ITASCA DOCUMENT REVIEW

File No.: 006-01-59

Document Title: "Modification of Rock Mass Permeability in the Zone Surrounding a Shaft in Fractured Welded Tuff" by John B. Case and Peter C. Kelsall (SAND86-7001, March 1987)

Reviewer: Itasca Consulting Group, Inc.  
(K. Wahi, M. Christianson and L. Lorig)

Exhibit 1 Comparison of Reported and Estimated Laboratory Relations Between Effective Normal Stress and Relative Permeability

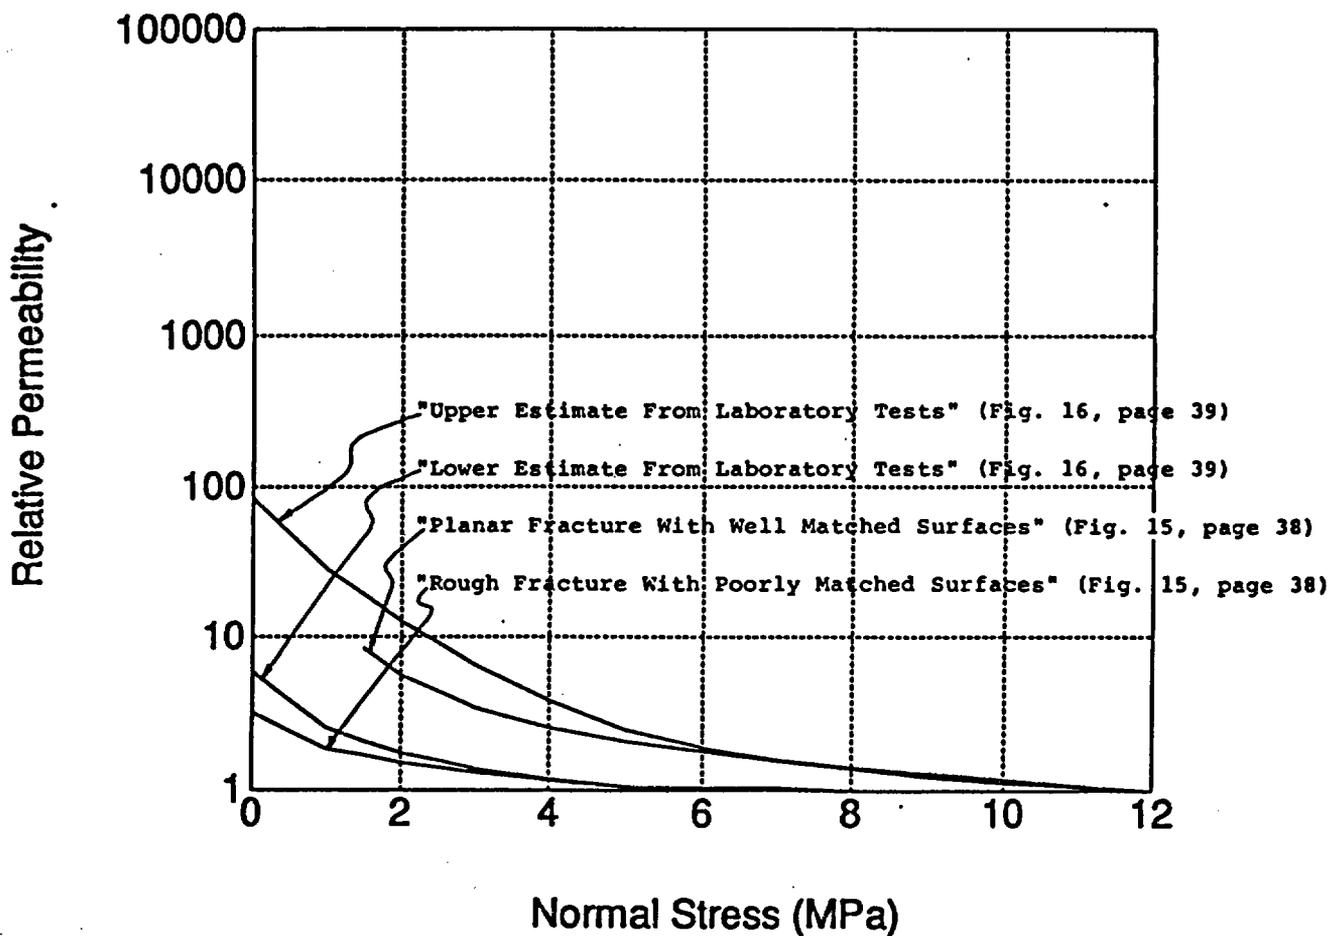
It is not clear how the curves in Fig. 16 (p. 39) were derived. It does not appear that the curves were obtained from laboratory data or from Peters et al. (1984). Exhibit 1 shows a comparison of the actual laboratory data in Fig. 15 (p. 38) plotted on the same scale as estimated upper and lower bounds in Fig. 16. Exhibit 1 indicates that both curves in Fig. 16 lie above the corresponding laboratory data.

Exhibit 2 Comparison of Two Estimated Laboratory Relations [Case and Kelsall (1987) and Peters et al. (1984)] Between Normal Stress and Relative Permeability

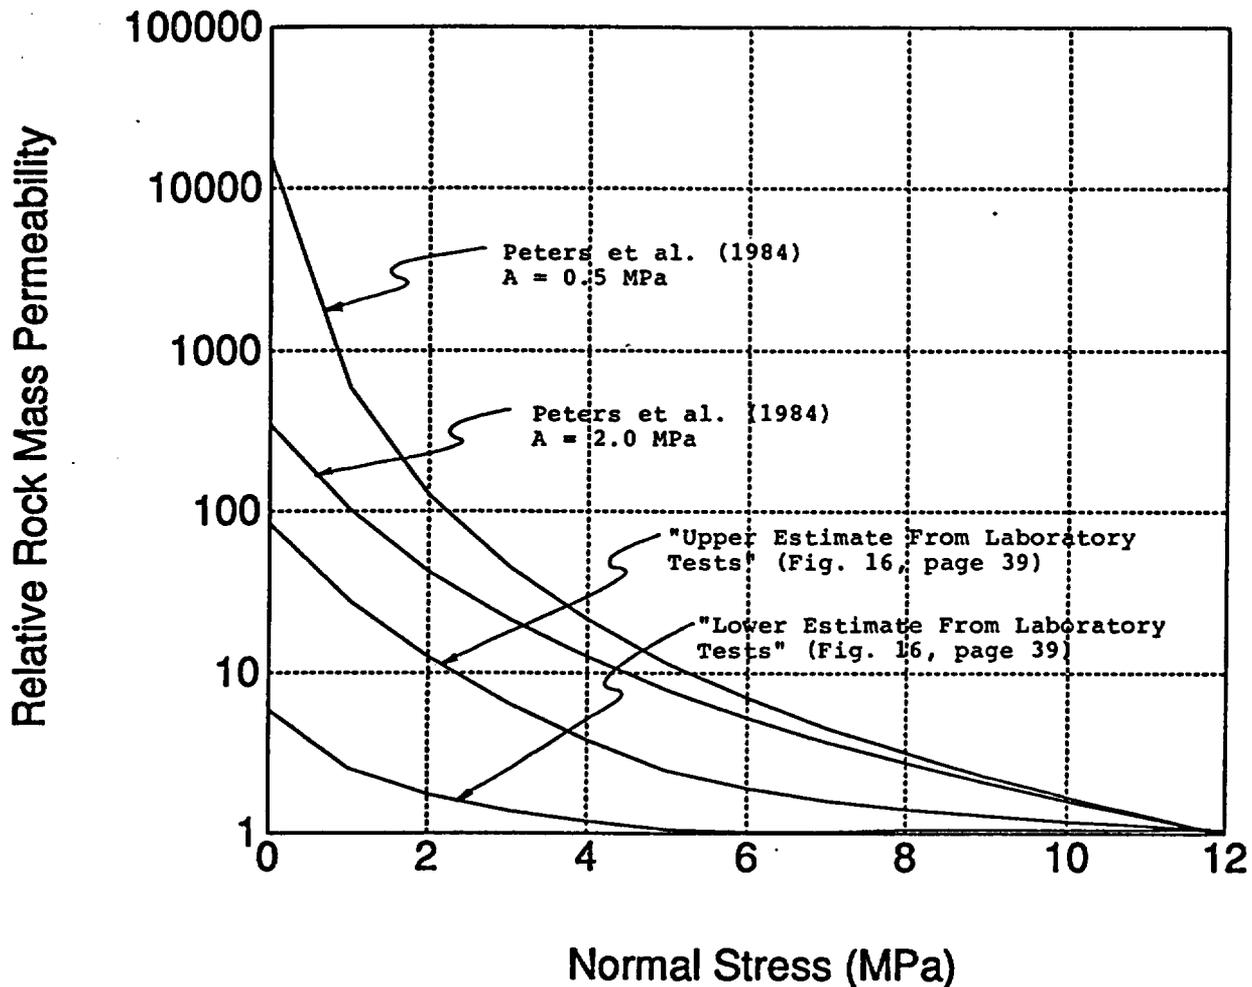
It also does not appear that Peters et al. (1984) has been used to calculate curves in Fig. 16. Rewriting the normal stress-closure relation [Eq. (1)] given by Peters et al., the aperture can be calculated as:

Using Eq. (3) and the values of  $A$  and  $U_n^0$  reported in Appendix O of the SCP-CDR (SNL, 1987), the aperture at any normal stress<sub>0</sub> can be calculated. For relative permeability calculations,  $U_n$  becomes unimportant, and any changes in the value of  $A$  cause relative permeability changes. The permeability ratios are calculated relative to the aperture at 12 MPa normal stress. This results in a relative permeability increase, at 0 MPa, of 343 to

15,625 for values of A of 2 to 0.5, respectively, as shown in Exhibit 2. It is important to note that, at low values of normal stress, the injection fluid pressure becomes a very important factor because the fluid pressure can cause an increase in aperture.
